DEFENSE NUCLEAR FACILITIES SAFETY BOARD

April 8, 1994

SUBJECT: Report of Trip to Old HB-Line - Rooms 302, 304 & 306

LOSS OF NORMAL POWER AND 292-H DIESEL

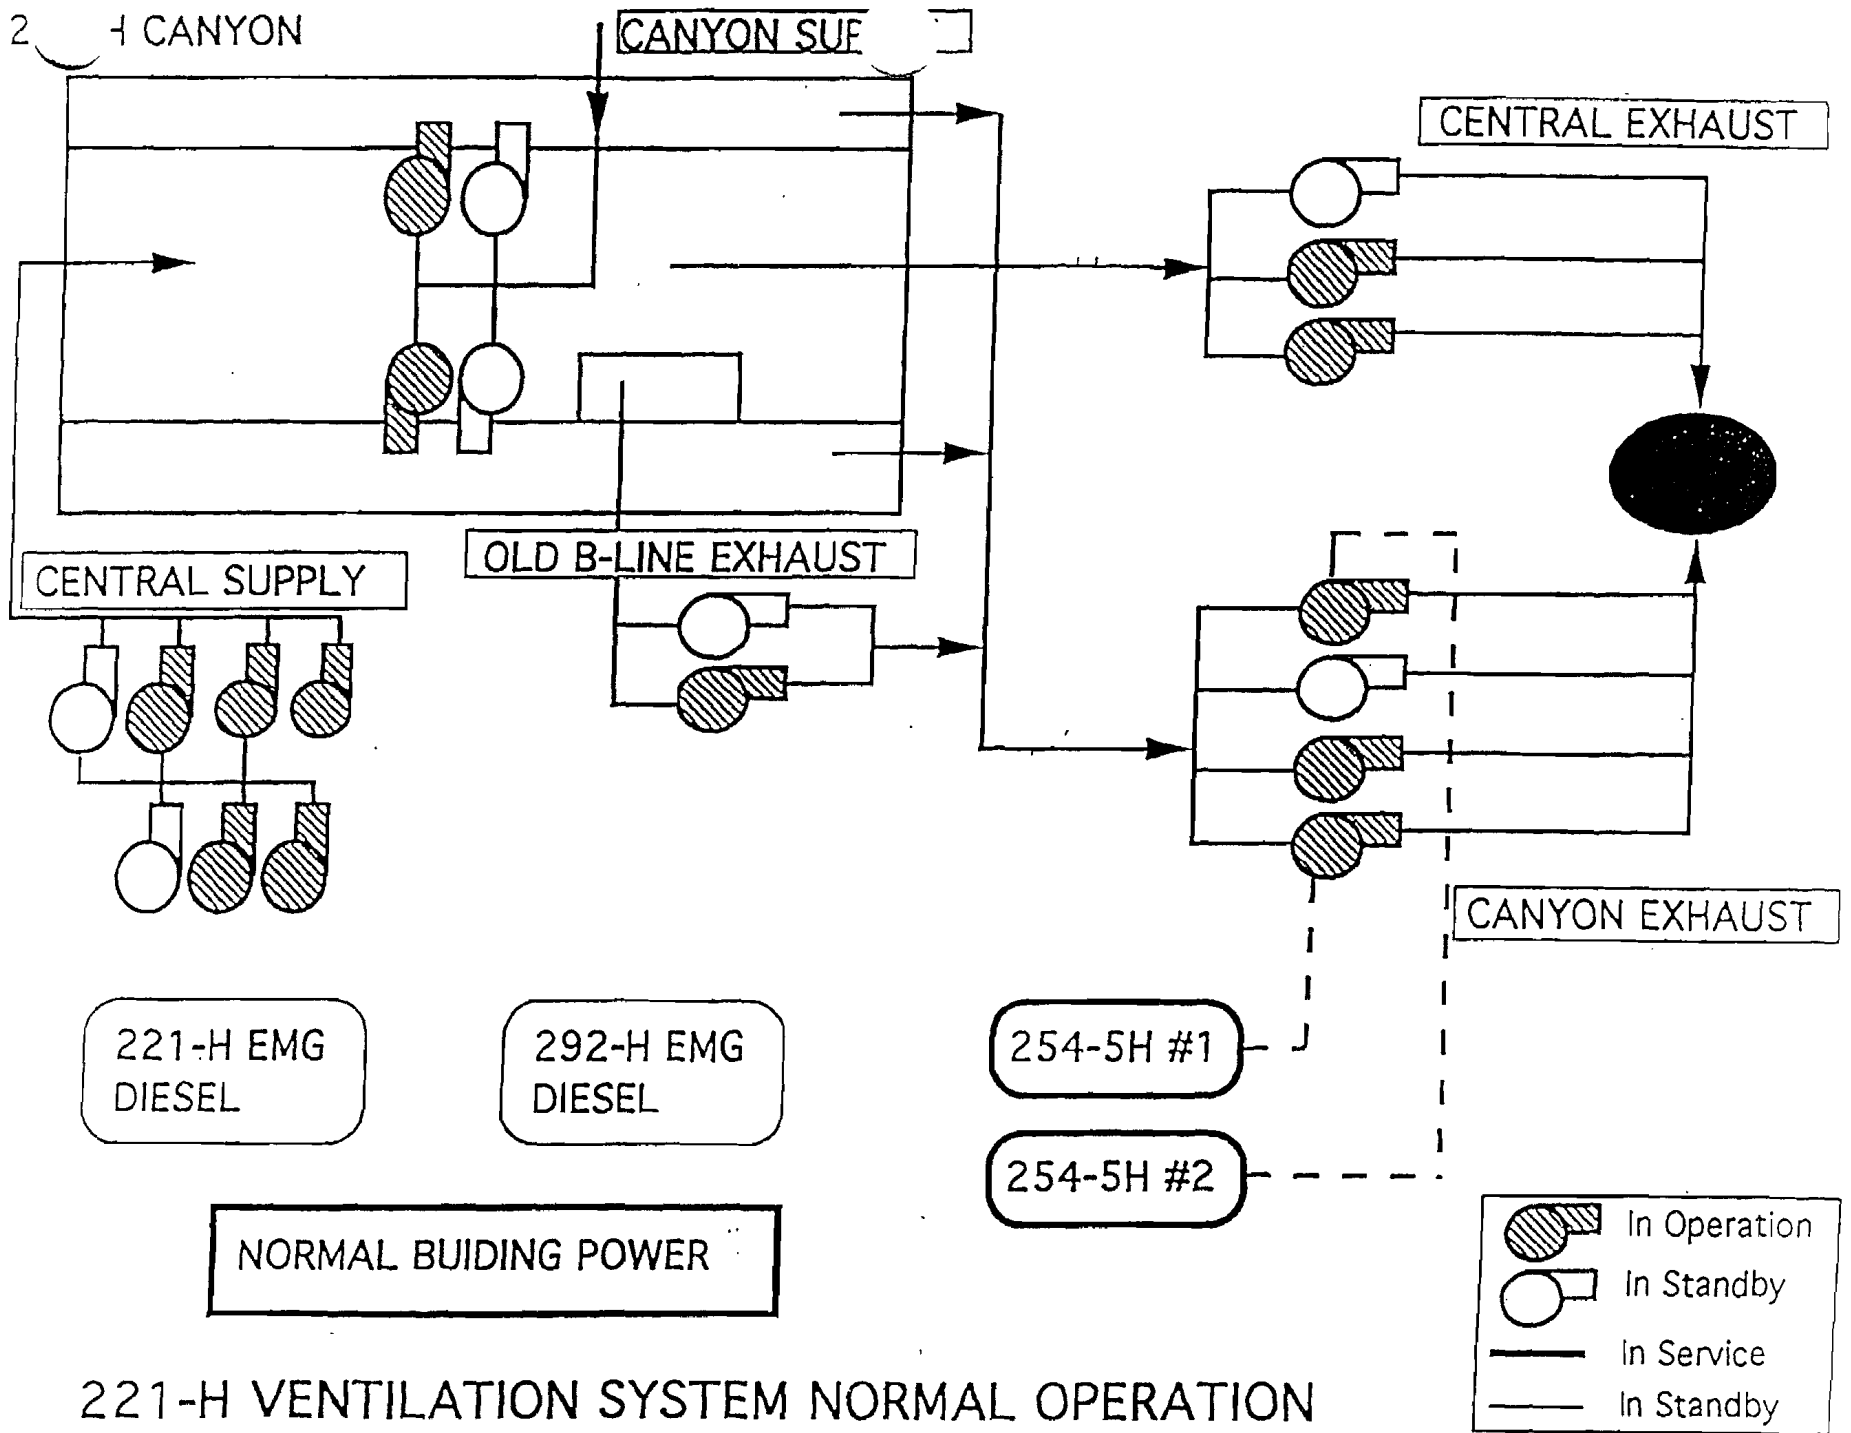
2. **Summary:** The following major issues and observations were identified:
 - a. An air flow reversal event, similar to the airborne contamination event that occurred in October 1993, will occur upon loss of normal power and the 292-H diesel.

The electrical feed configurations of supply and exhaust fans for these scenarios are presented schematically in Attachments 1 through 4. Attachment 5 provides the configuration for the normal operation of the ventilation system. Air reversal will not occur in scenarios 1 through 3. However, scenario 4 will lead to air flow reversal in room 306. It is anticipated that the Department of Energy (DOE) will evaluate this scenario and provide timely corrective action.

- a. Evaluate and implement the corrective action to prevent any air flow reversal in room 306 due to loss of normal power and 292-H diesel.
- b. Evaluate and implement the corrective action to install a fire detection system and to start fire watches.
- c. Evaluate and implement the corrective action to prevent the exposure of workers to the airborne contamination due to existing holes and cracks in the doors of room 306.

ATTACHMENT 6

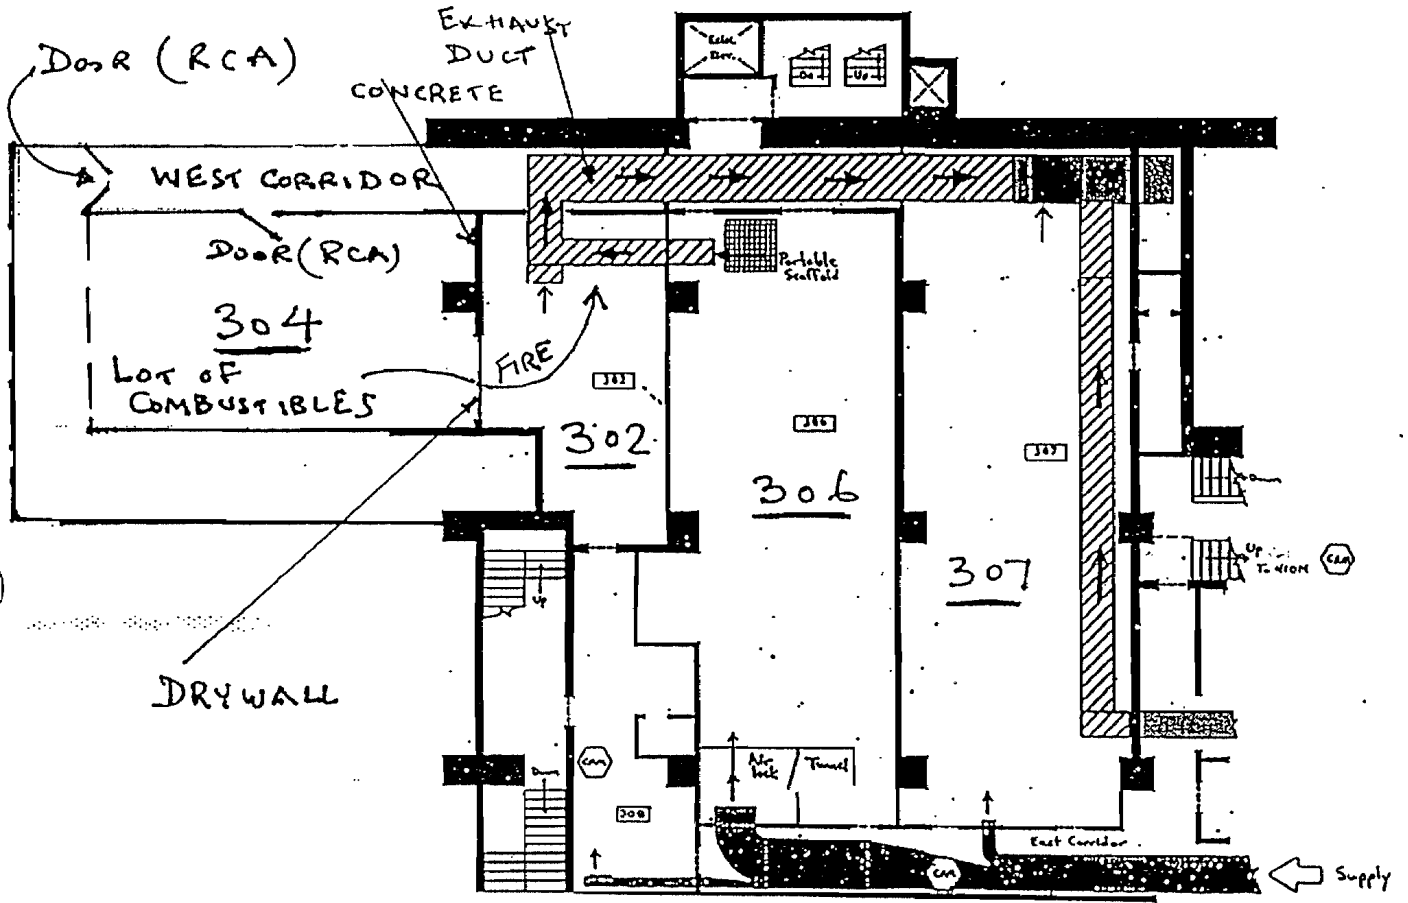
- b. Room 304 contains a sufficient amount of combustible materials to create a severe fire hazard. The room contains no fire detection devices. Also, if a fire in room 304 is sufficiently intense, there is the possibility of its propagating to the adjacent room 302, with possible melting of the 16 gauge ventilation duct, and resulting in an air flow reversal and airborne contamination.

A severe fire in room 304 has the possibility of propagating through a drywall to the adjacent room 302, which contains the exhaust ventilation duct for room 306 (Attachment 6). Under such conditions there is a possibility that the 16-gauge exhaust duct material in room 306 could melt during a fire and this could result in an air reversal and airborne contamination.
